PLANNING APPLICATION REFERENCE APP/18/00897

15 Langstone Road, Havant - Erection of 9 no 2 Bed Flats Following Demolition of Existing Dwelling

Statement in response to Objection by Mr P Galloway (letter dated 28th September 2018)

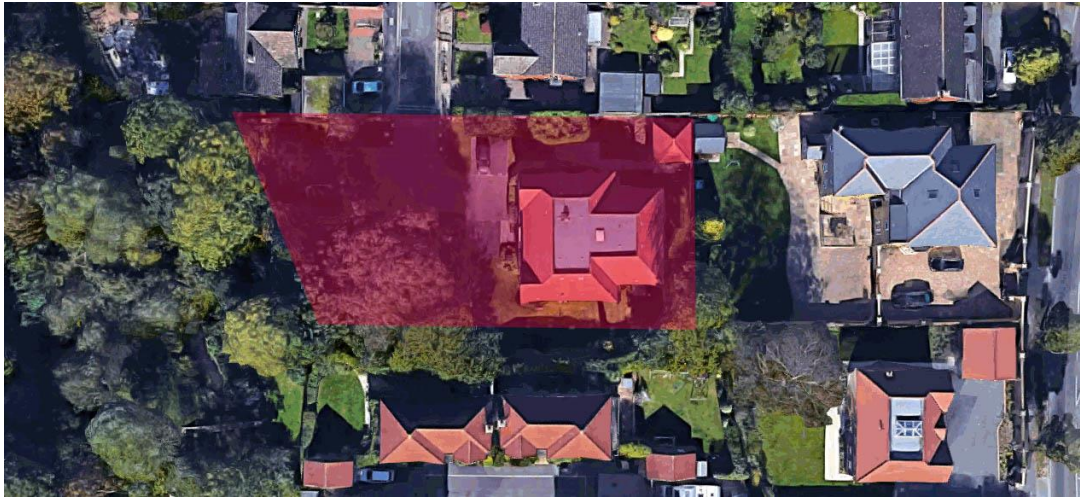
- 2.01. The resultant density would be incongruous in its context and out of character for the area.

The density of this scheme is considered appropriate to development of this type. Furthermore, the applicant and design team have identified similar developments within close proximity of the site which reflect the appropriateness of the proposed density of 30 dwellings per hectare (DPH).

The first is at Longmead Court, some 160 yards to the south of this site, which occupies 12 flats on a site area of approximately 0.19 hectares, giving a density of 63 DPH

Another is at the development between The Mallards and Brookmead Way, some 180 yards walking distance, which recently saw the approval of 6 flats on an area approximately 0.14 hectares in size, giving a density of 43 DPH
